# MANDATORY BULLETIN No. E 23/009a

Effectivity: Gliders L23 Super Blaník prod. num. 897501 to 917930

Reason: Wheel spur adjustment

1

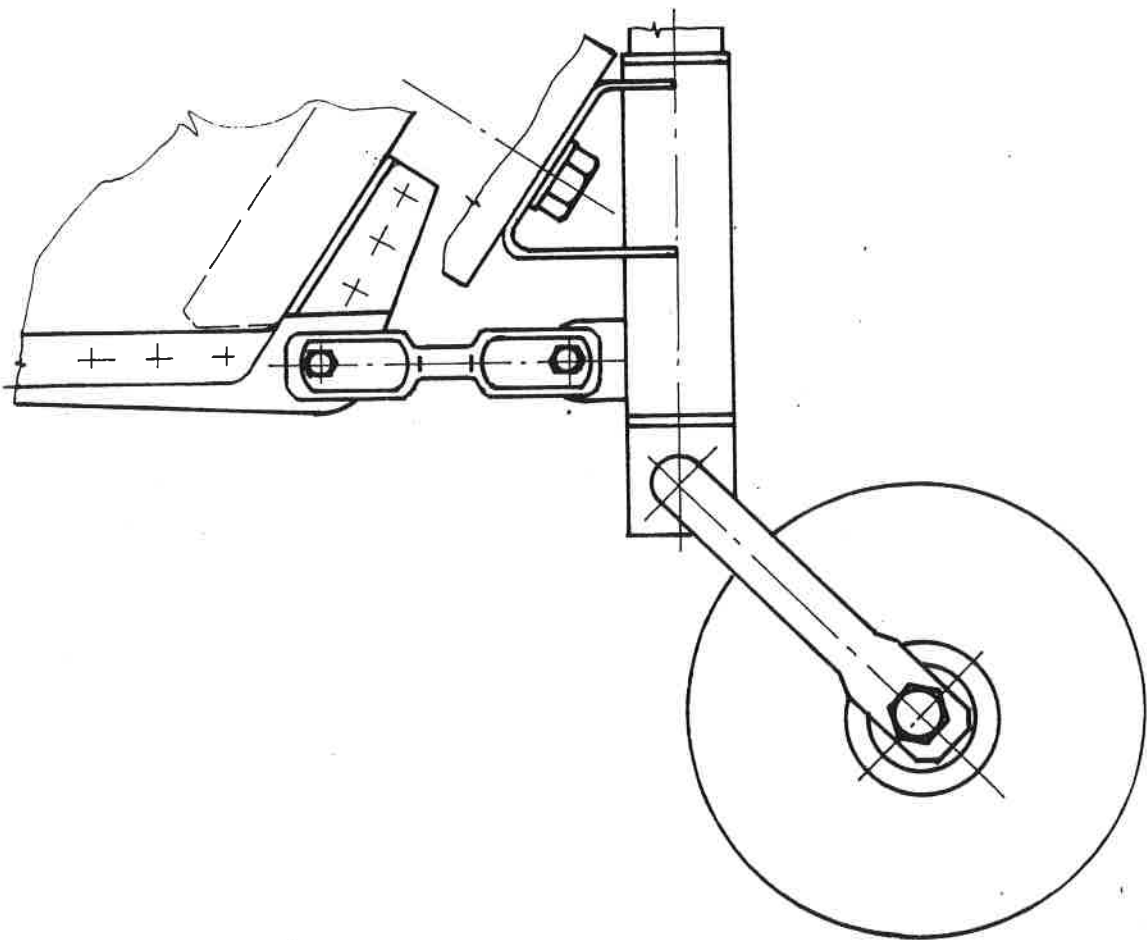
Description: Spur rod is replaced with two side plates with elastic elements according to following text in bulletin. In serial production it is introduced by a change nr. ZKA 70144 beginning with production number 918001.
